PONTIAC

Service Craftsman News

No. 2 S-291

February, 1957

Fig. 1 Taping of Power Seat Solenoid Cover

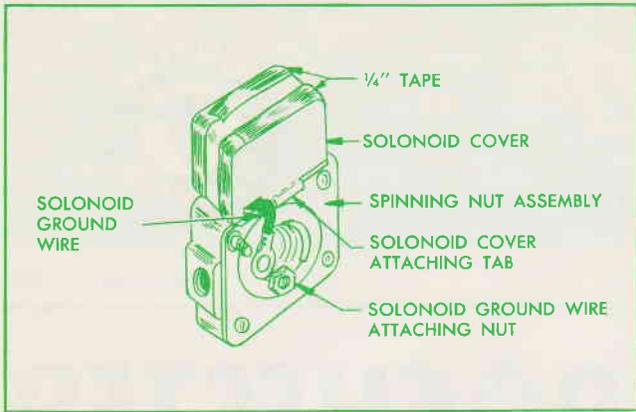
We have received several field reports concerning loose solenoid covers on early production bodies equipped with power operated six-way seat assemblies. This condition can be corrected by first disconnecting the solenoid to spinning nut ground wire, straightening the solenoid cover attaching tabs; then wrapping three (3) or four (4) layers of 1/4" wide tape around the front and rear edge of the solenoid cover as shown in Fig. 1.

When the cover has been securely taped, carefully crimp the solenoid cover attaching tabs tight over the tape and secure ground wire with the attaching nut.

Changes have been made to correct this condition in production by using a specially designed clip to retain the solenoid cover.

FIG. 14

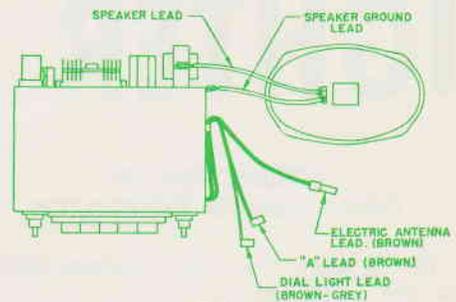
We have found that the connections of the radio unit and speaker in the installation or re-installation of Pontiac radio Model #988671 has caused some confusion in the field resulting in speaker failures. The radio has three leads that may connect to the car and there are two leads from the speaker to the radio. The diagram below identifies these leads.

Speakers can be damaged by incorrect connection of the speaker leads to the radio. The ground lead can be forced into the electric antenna lead and this places 12 volts D.C. on the voice coil of the speaker and ruins the speaker. This lead should connect to the ground lance on the radio case near the output transformer.

The "A" lead and dial light lead are a two wire "rip-cord" type cable and the dial light section of the lead has a gray strip. The electric antenna lead is a single lead with a plastic connector and is used only when the car has an electric antenna. The speaker leads are also in a "rip-cord" type cable. The signal lead has a green strip and plugs into a connector on the output transformer. The ground lead connects to a lance stamped from the radio case at the base of the output transformer.

Fig. 2 Old and New Rear Door Guide Shoe Spring

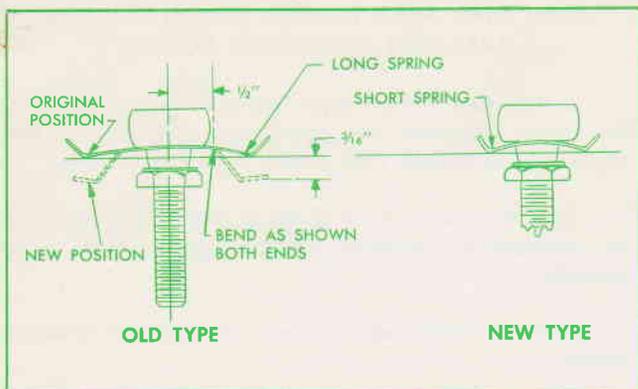
If rear door window rattles are encountered on 4 Door Catalina bodies they may be due to insufficient tension of the rear door window center guide shoe against the center guide. The lack of tension is a result of the long center guide shoe spring (See Fig. 2) used in some early production 1957 bodies. This condition may be corrected by bending the spring, as indicated in Fig. 2, to increase the tension of the shoe against the guide. A shorter spring is now being used in production which will provide the required tension.
